Changing assigned Class through DLL v102

Change history

v102 Improved explanation in 33.3.6 pertaining to PDs not being allowed to LLDP beyond their requested Class. We now have the SHALL statement on page 153, line 47 and an explanation on page 154, line 22.

Change Figure 33–15 on page 95 as follows:

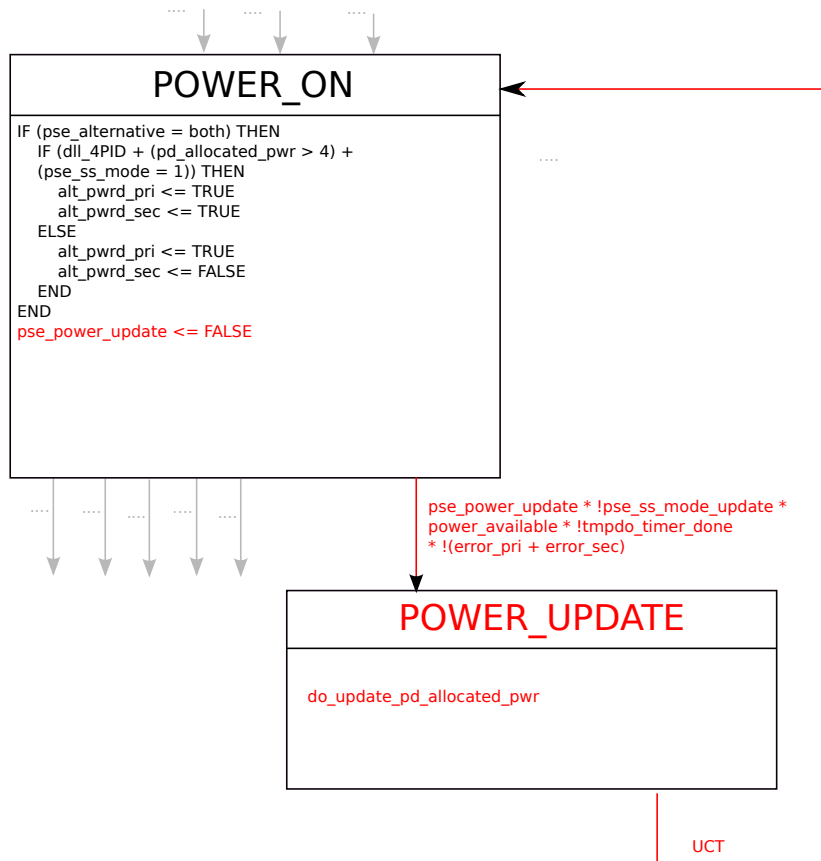
33.2.5.12 Type 3 and Type 4 state diagrams

Change Figure 33–32 as follows:

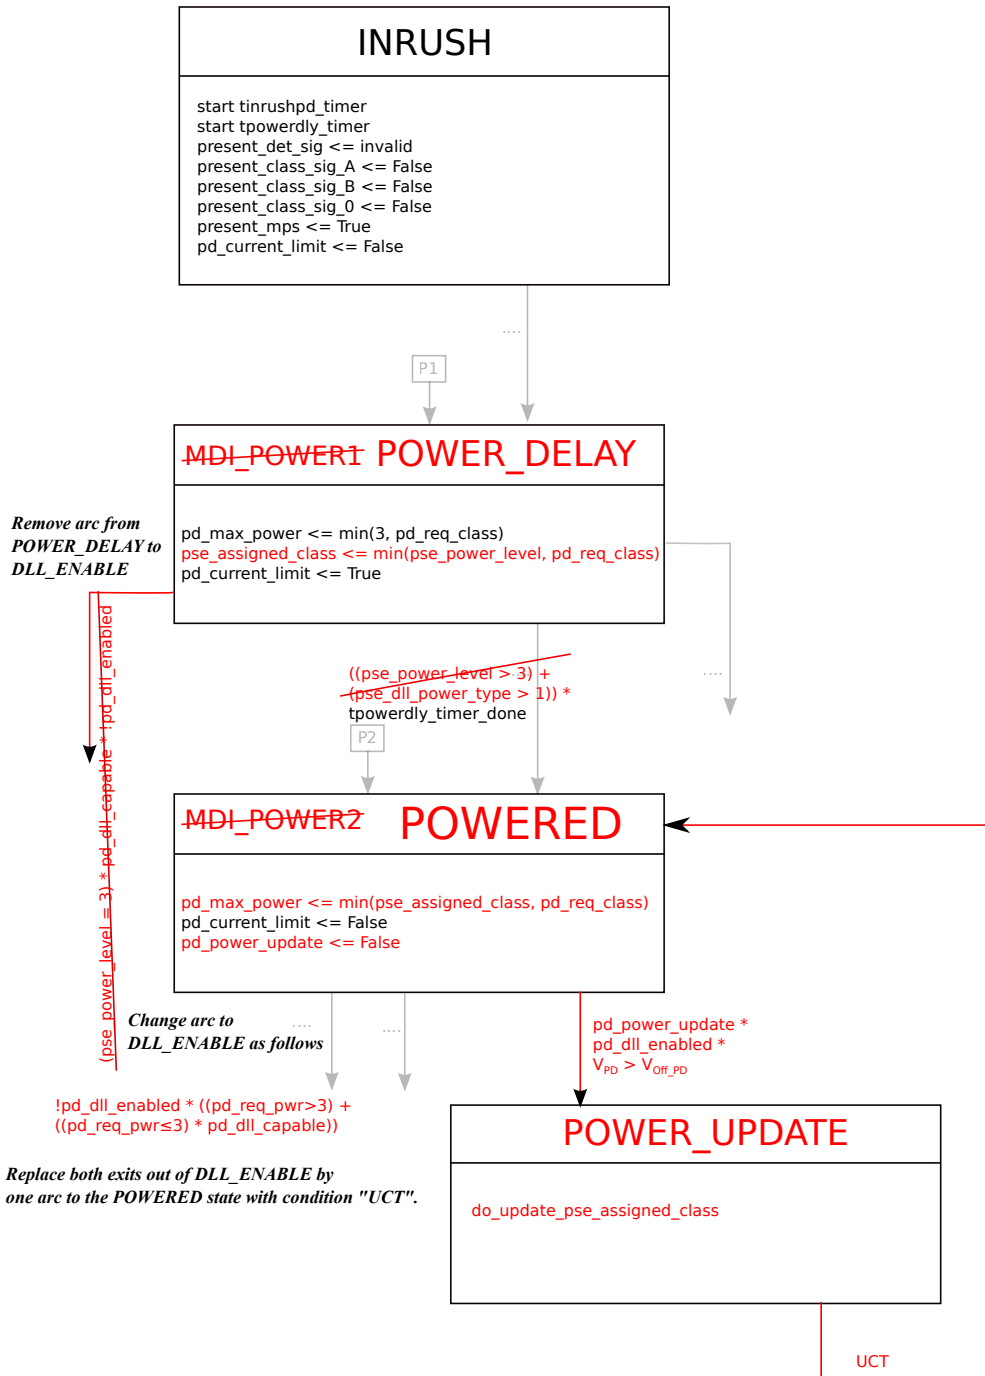
33.3.3.11 Type 3 and Type 4 single-signature PD state diagrams

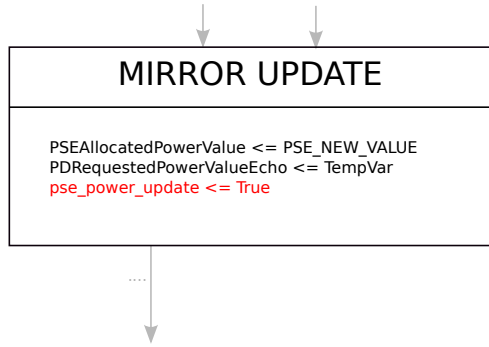
The following non-normative text is added to explain that it is not permitted to draw more power than the requested Class. The actual requirement is in the PD state diagram, as well as on D2.2, page 153, line 47.

After a successful DLL classification, the assigned Class changes depending on the value of PDMaxPowerValue variable, as defined in Table 33–24. The PDs maximum power draw is limited to the power level corresponding with its requested Class, regardless of DLL classification.
